# ADMINISTRATION REPORT **REZONING, PLAN AMENDMENT** GARNEAU

## **8630 to 8642 - 108A Street NW** **8715 - 109 Street NW**

To allow for a high rise residential tower.

**Recommendation:** That Bylaw 19480 to amend the Garneau Area Redevelopment Plan and Charter Bylaw 19481 to amend the Zoning Bylaw from a Site-Specific Development Control Provision (DC2.528) and the (RA7) Low-Rise Apartment Zone to the (CB1) Low Intensity Business Zone with the Main Streets Overlay and a new (DC2) Site Specific Development Control Provision be APPROVED.

APPLICANT RENDERING LOOKING SOUTHEAST WITH SURFACE PARKING SITE IN THE FOREGROUND AND PROPOSED TOWER BEHIND

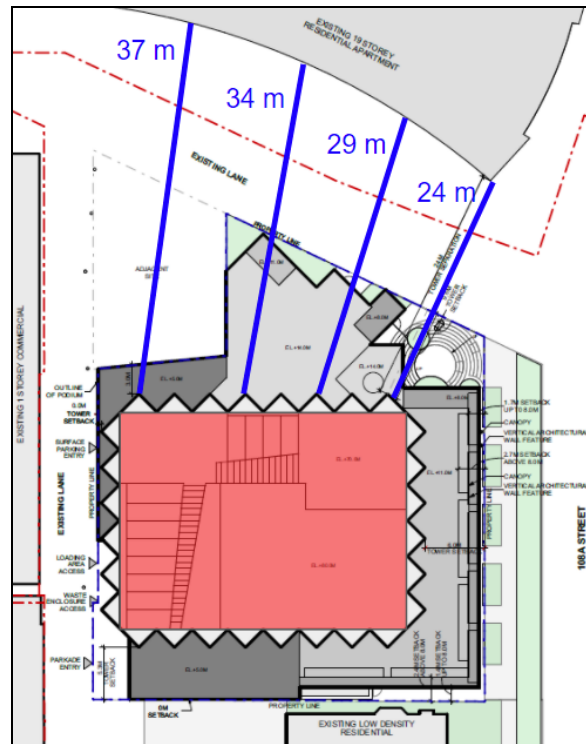
The interface of this site with the proposed tower will essentially have solid walls of the proposed development at the property line, approximately 4 storeys to the east and 1 storey to the south with the proposed 70.0 metre tall portion of the tower 3.0 metres back from the property line to the south. The below rendering prepared by the applicant shows this surface parking site with the proposed tower behind it.

While this is certainly an abrupt transition, considering the likelihood of surface parking remaining on the site going forward, this is considered acceptable.

SITE PLAN SHOWING THE FIVE VIEW ANGLES FROM EACH COLUMN OF BALCONIES

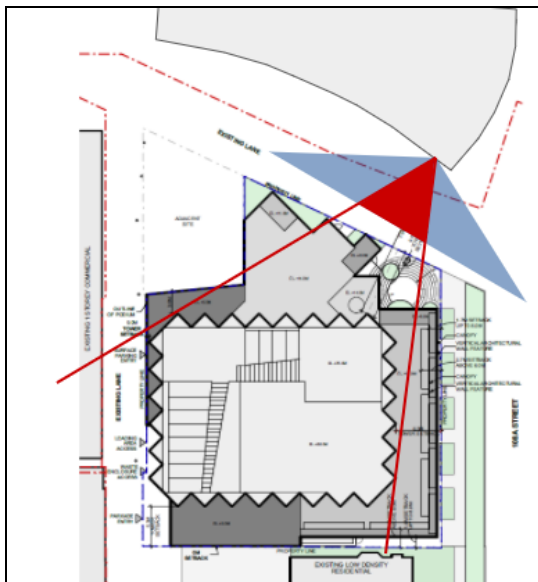
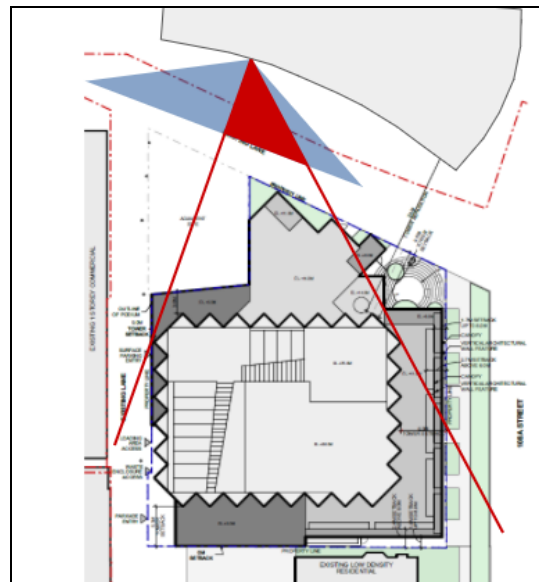
When looking at each column of balconies individually, the level of obstruction from the proposed tower varies from approximately 27% to 31%. The images below show the obstructed portion of the view in red. A full analysis for all columns is found in Appendix 3.

Put another way, between 69% and 73% of existing views from Strathcona House will remain unobstructed if the proposed tower is built. As was the case with sunlight access, it needs to be recognized that having 100% unobstructed views is the exception, and it is much more common for dwellings in areas where there are higher concentrations of residential towers to have a portion of the view obstructed by another tower.

**Appendix 1 – Site Plan – Revised After Council Motion**

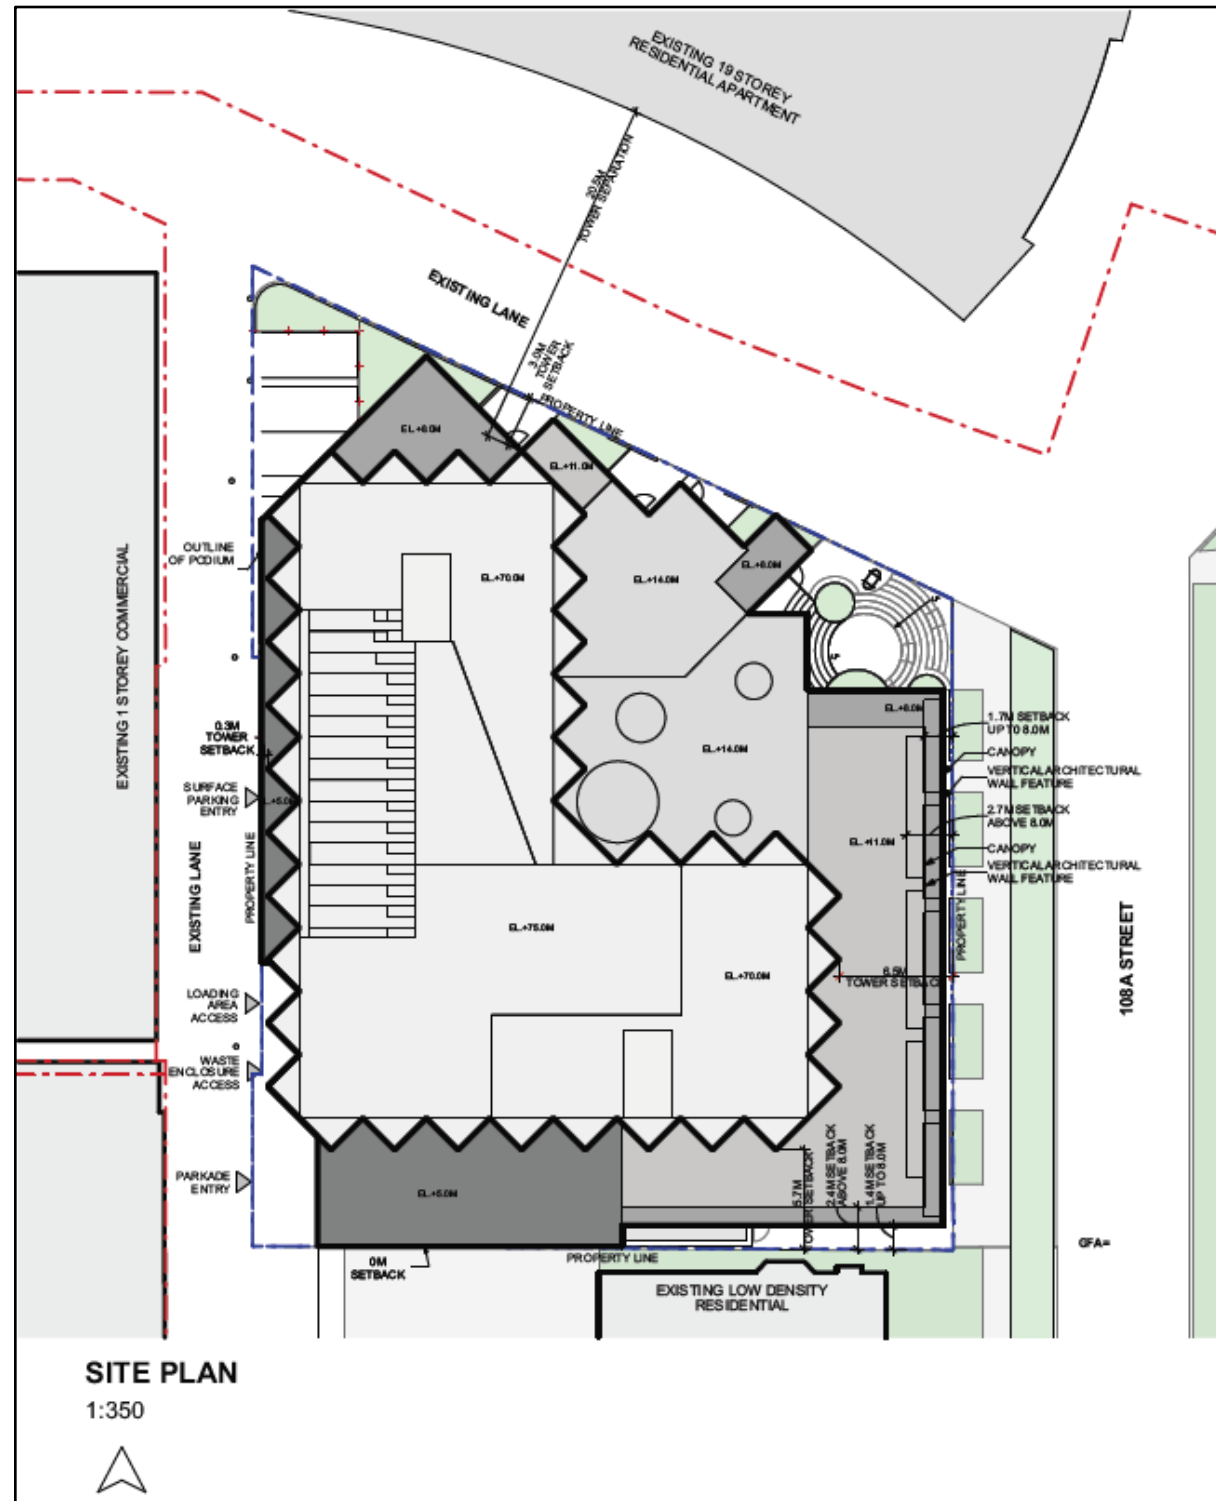
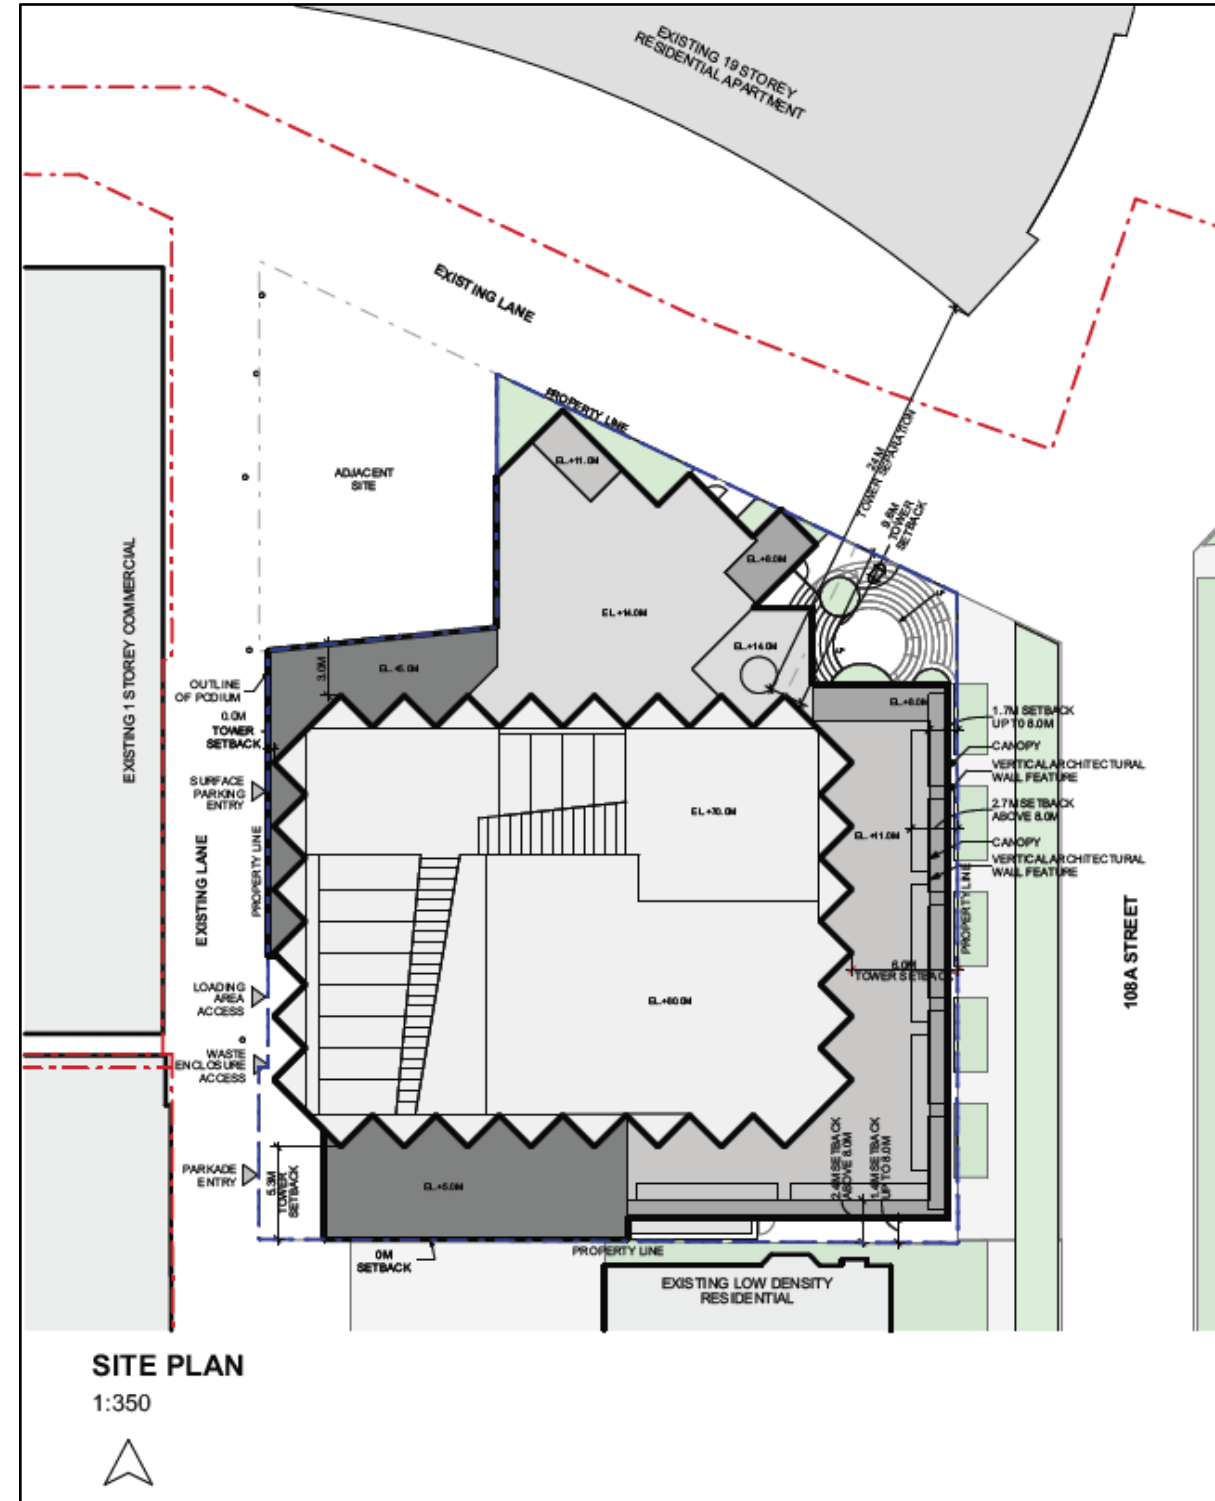
- Removing 8650 - 108A Street NW from the rezoning site;
- Adjusting the proposed tower from an "L-shape" to a rectangle;
- Increasing the maximum height from 70-75 metres to 70-80 metres;
- Decreasing the maximum floor area ratio from 10.0 to 8.5;
- Decreasing the maximum number of dwellings from 271 to 245;
- Decreasing the maximum tower floor plate from 855 to 800 square metres;
- Removing ground oriented dwellings facing the lane to the north;
- Adjustments to some tower setbacks; and
- Adjustments to the types of community amenity contributions.

- b. 3.0 m from the north Lot line, ~~except for the portion of the Tower within 18.0 m of the east Lot line where abutting the minimum north Setback shall be 16.0~~ adjacent Site shown on Appendix 1 – Site Plan.
  - a. ~~6.5~~ 6.0 m from the east Lot line;
  - c. ~~5.7~~ 5.3 m from the south Lot line; and
  - d. ~~0.3~~ 0.0 m from the west Lot line.
7. The Underground Parkade below ground level shall not be subject to required Setbacks and can extend to all Lot lines.
  8. The maximum Tower Floor Plate shall be ~~855~~ 800 m<sup>2</sup>.

**Appendix 6 – Landscape/Amenity Area Ground Concept – Revised After Council Motion**

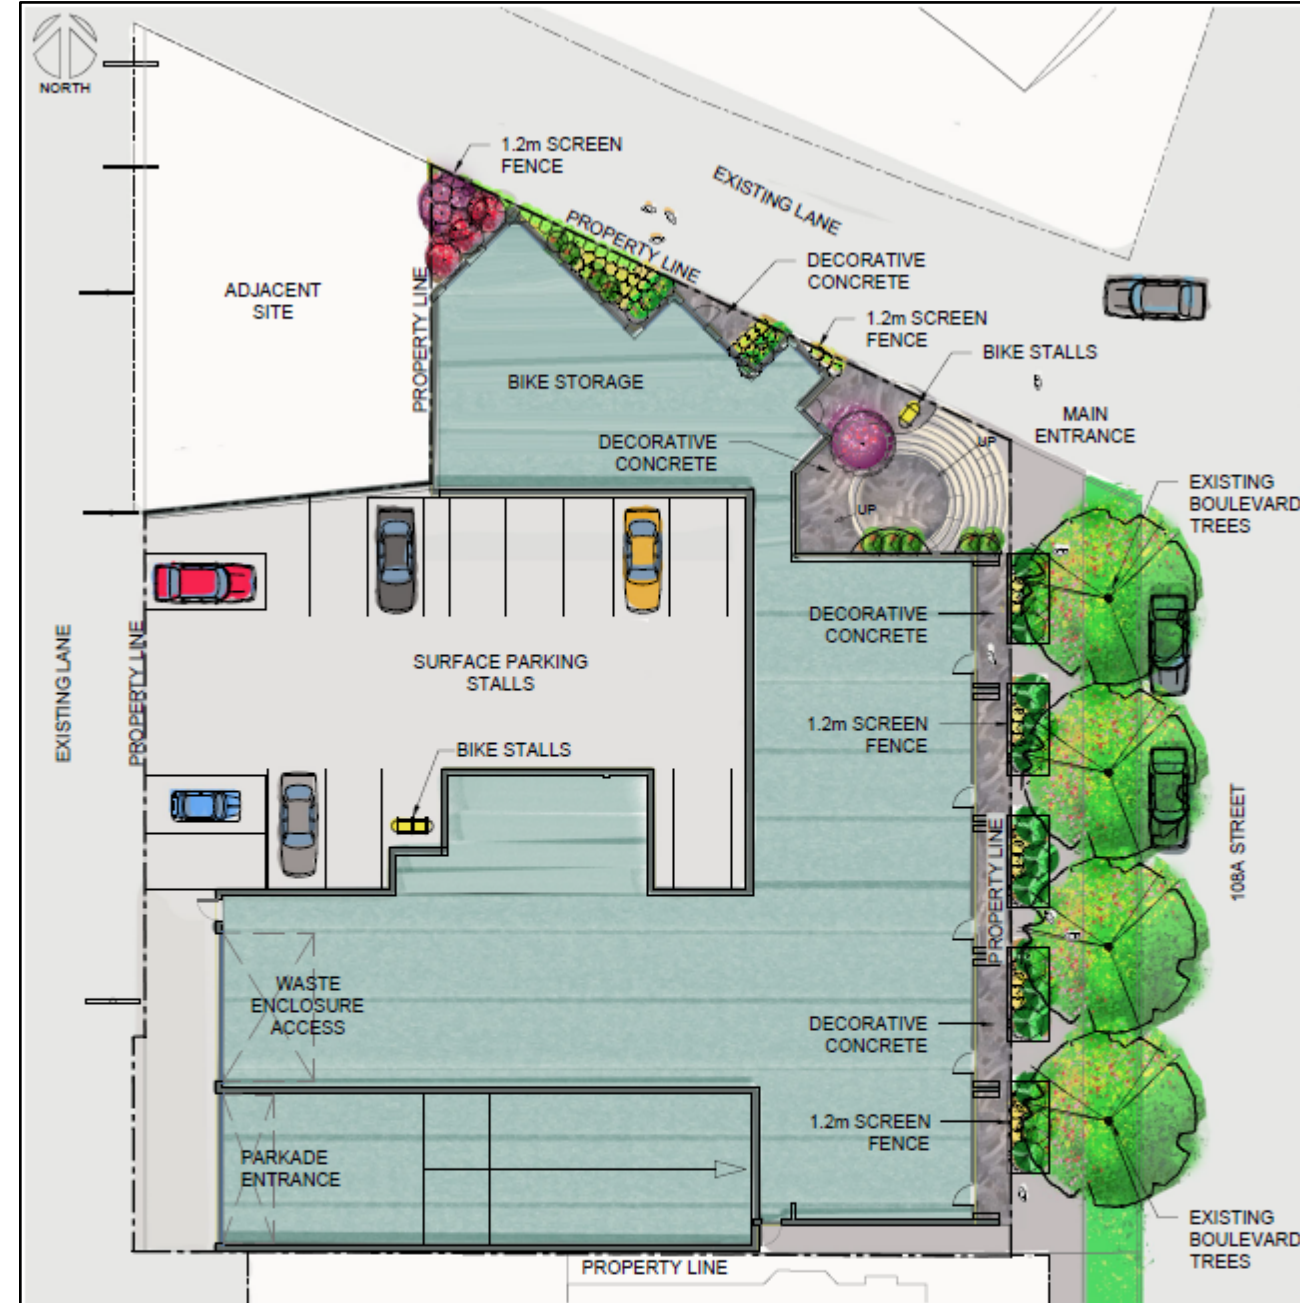
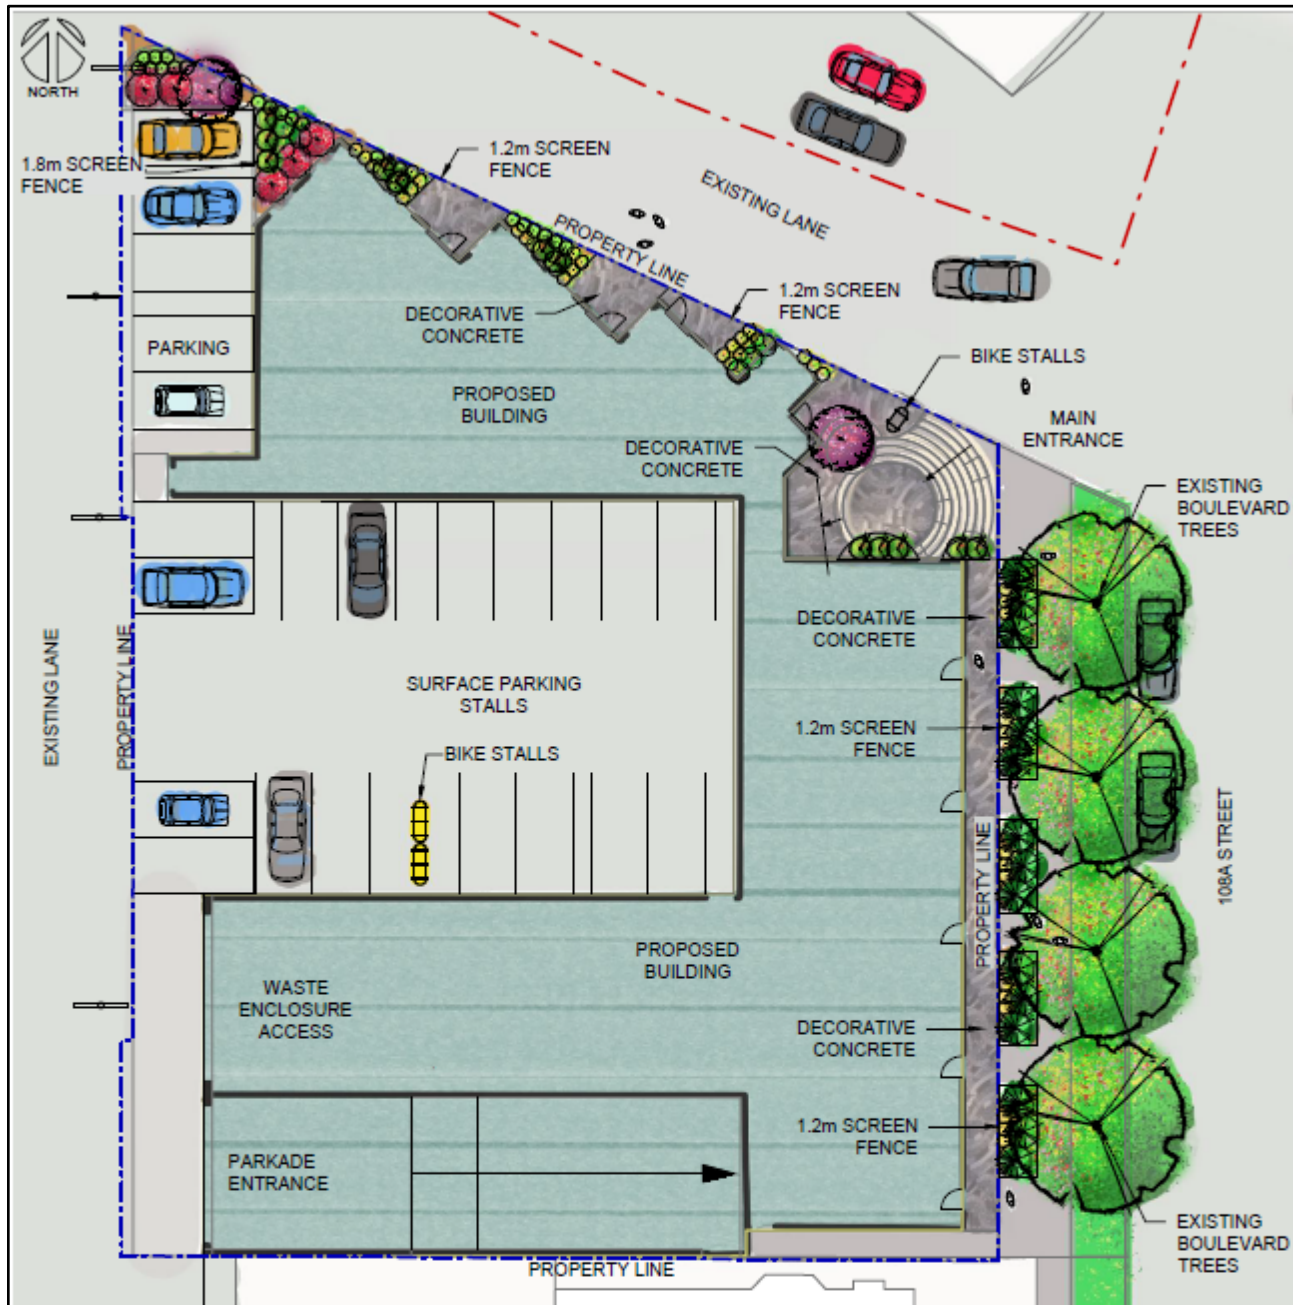
- b. Landscaping Plans shall incorporate native and/or drought tolerant species into the Landscaping design;
  - c. Setbacks from the ~~north and~~ east shall provide entry transitions including features such as steps, gates, hedges, low walls, for Dwellings fronting 108A Street NW ~~and the north Lane~~;

- d. Setbacks from the east shall provide a 1.5 m wide concrete walkway adjacent to Ground-oriented Dwellings fronting 108A Street NW; and
  - e. At ground level, the east and north Setback shall be Hardsurfaced and visually incorporated into the streetscape of 108A Street NW and the north Lane by providing paving materials, shrub beds, and/or planters to accommodate Landscaping that contributes to a high quality pedestrian oriented public realm.
